HIGHLIGHTED AA 2024 AREAS

la serena senior apartments
457 coors blvd. nw
albuquerque, new mexico 87121

revised permit set

a3.12

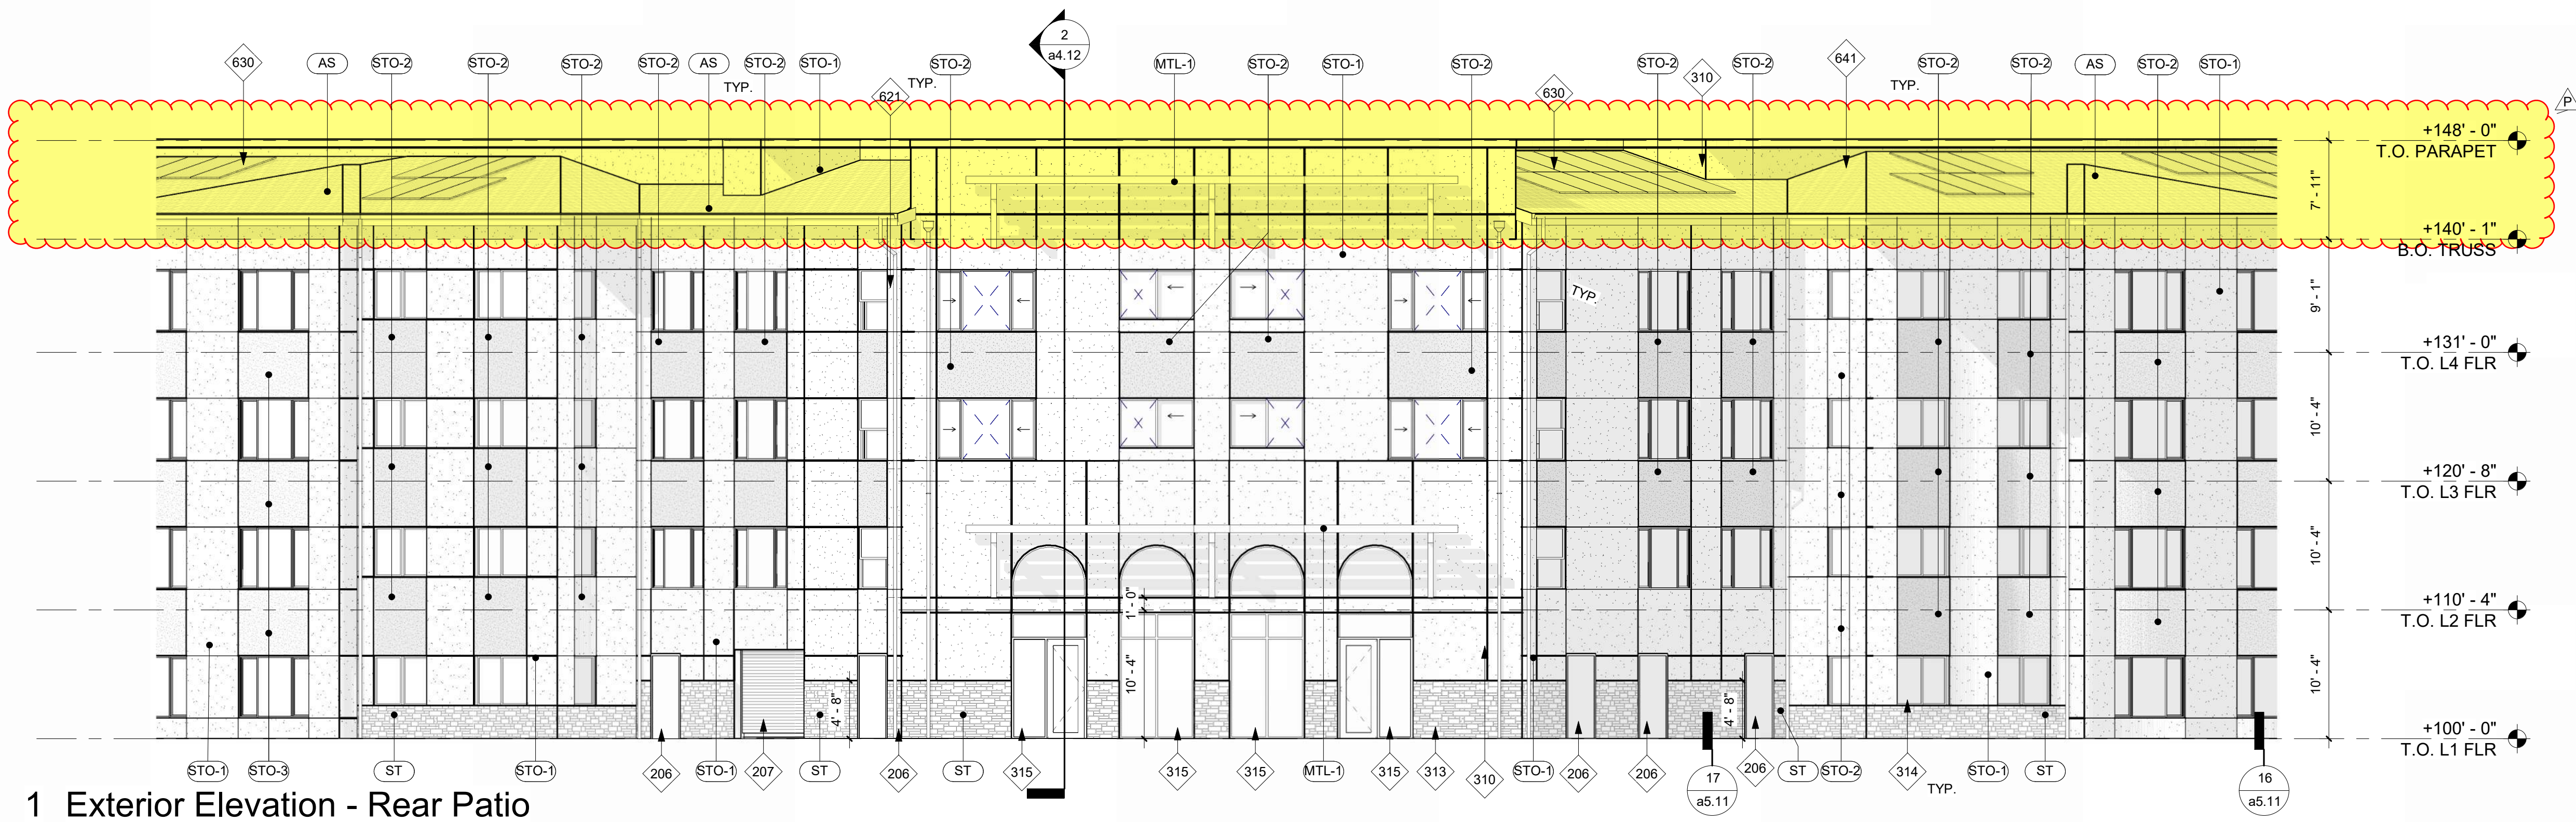
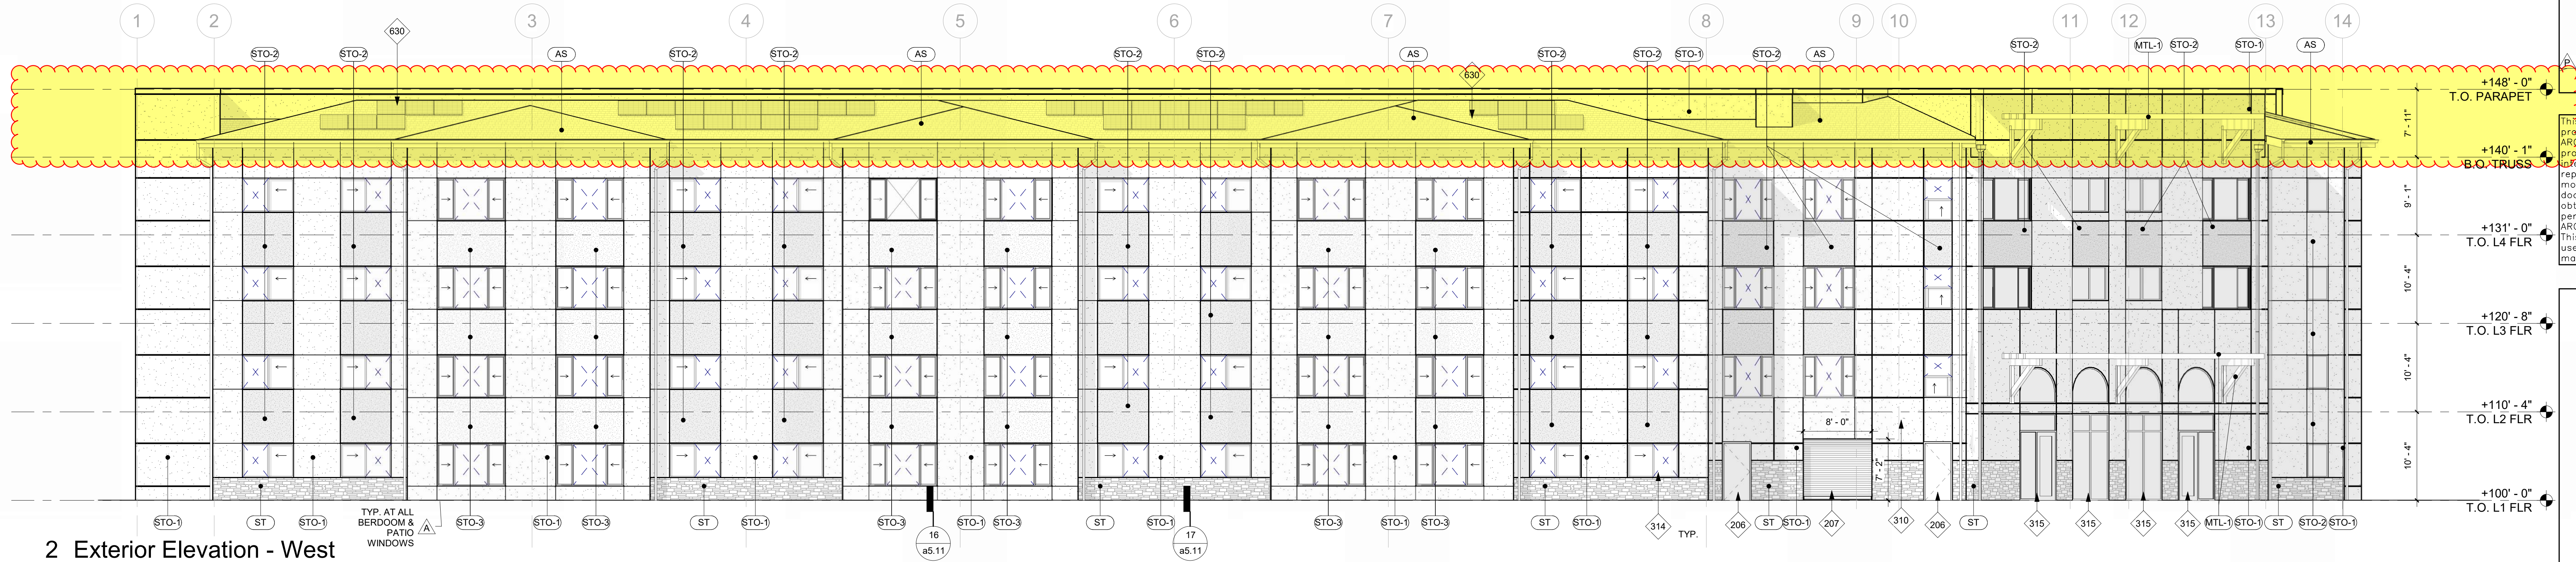
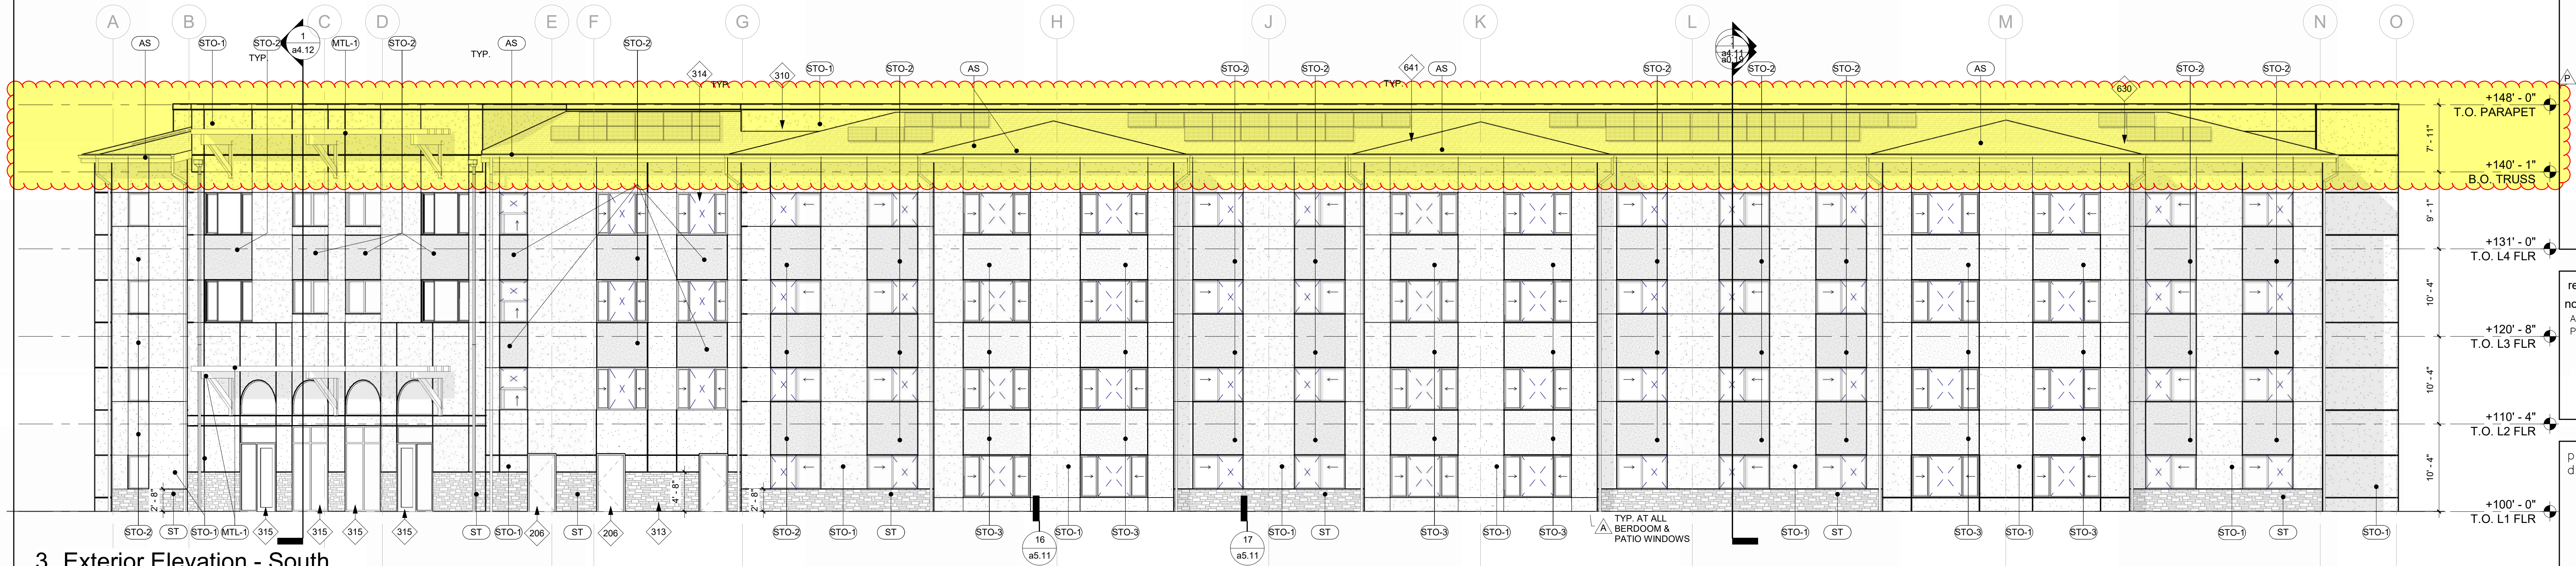
- 1.) Roof and parapet heights raised. Parapets now at 148'-0"
- 2.) Center "knuckle" of building roof removed in lieu of a parapet design
- 3.) Revised roof design at front entry parapet center "knuckle"
- 4.) Second trellis element added at rear patio parapet of center "knuckle"

3 exterior pedestal mailbox elevations
3/4" = 1'-0"

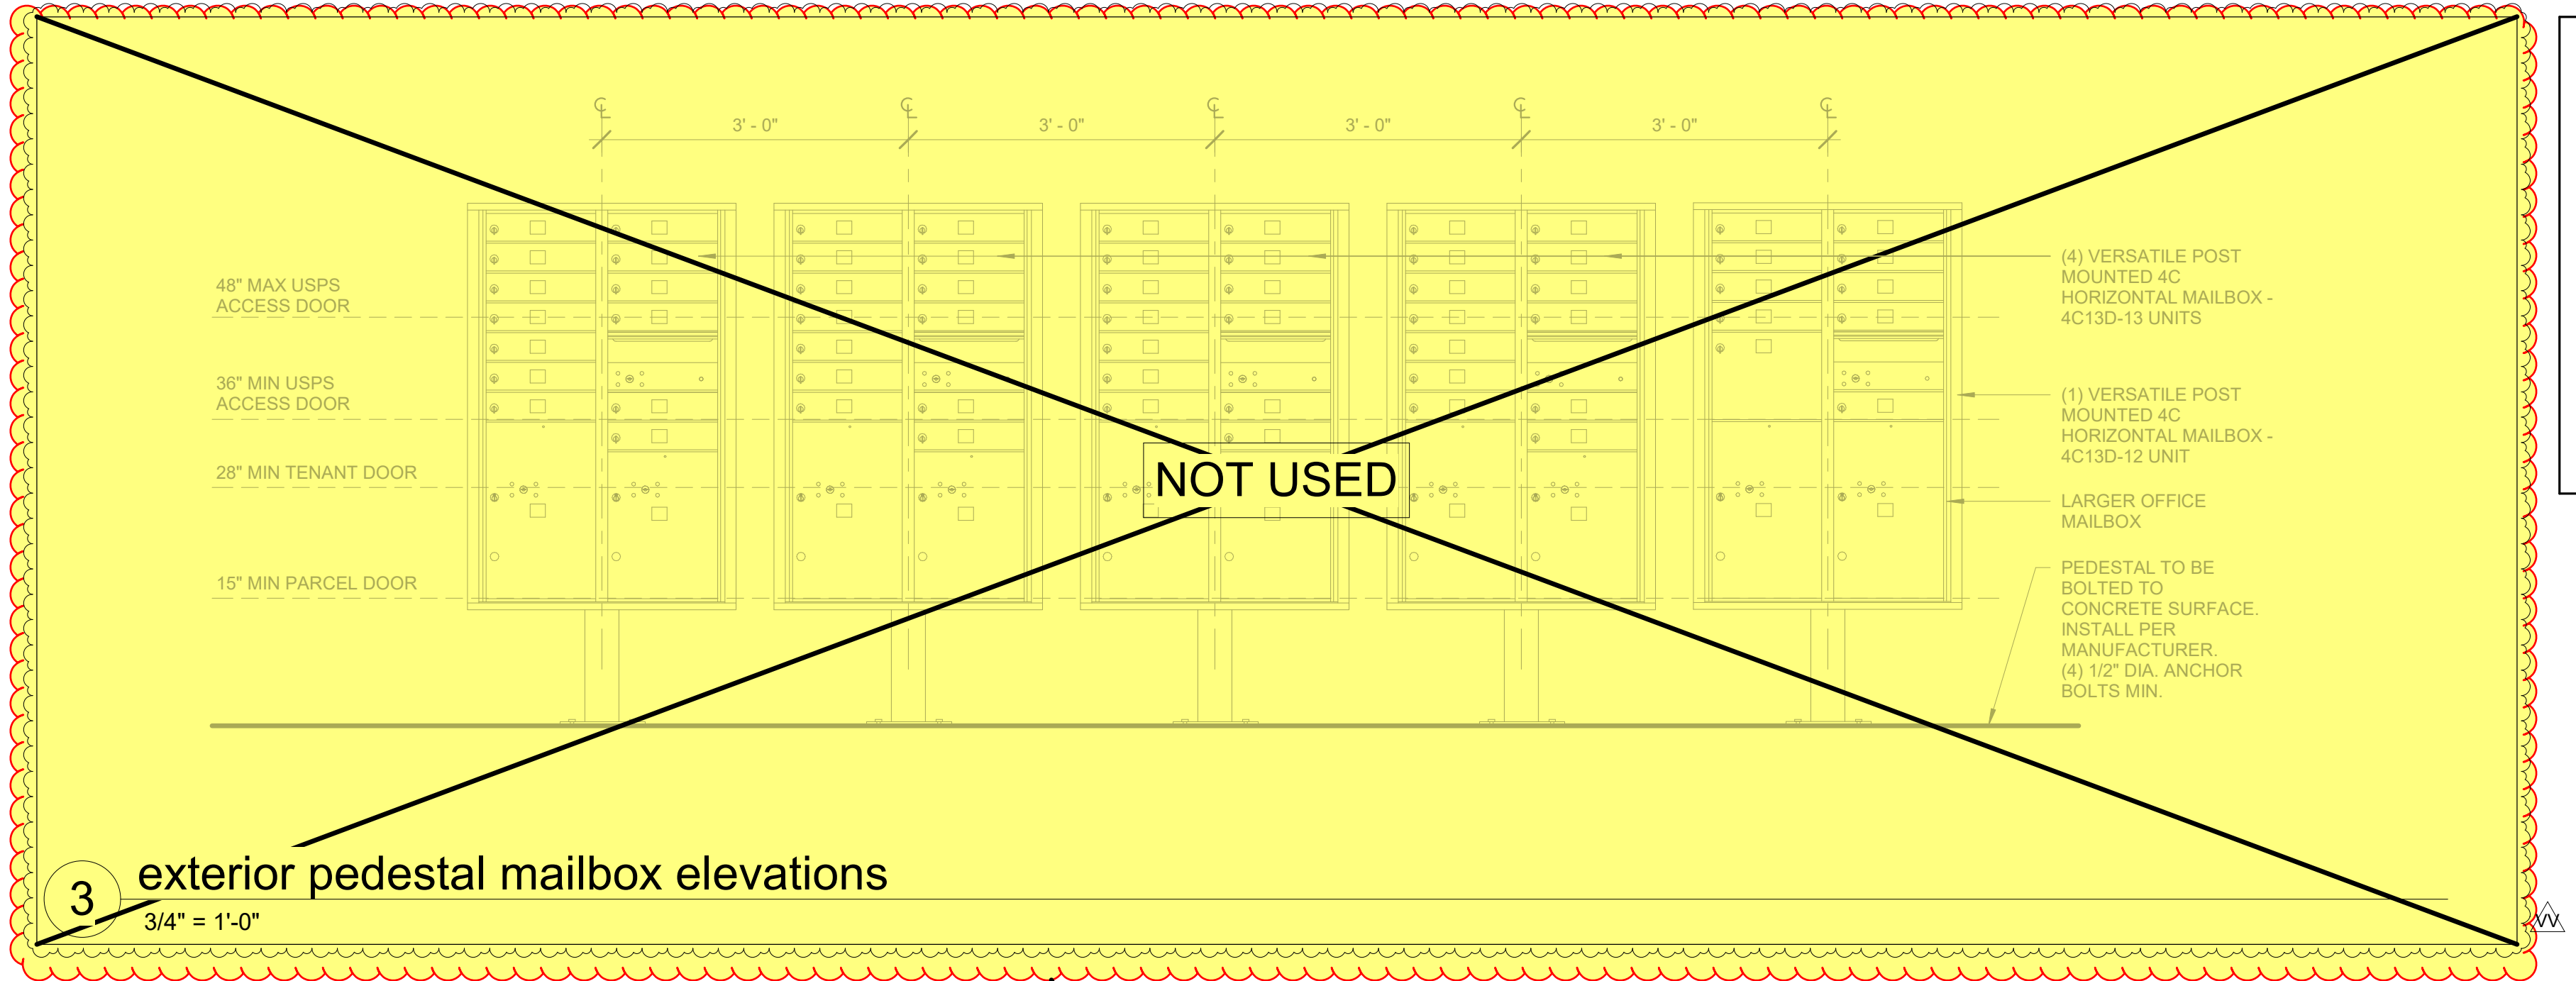
Exterior mailboxes moved inside, per USPS
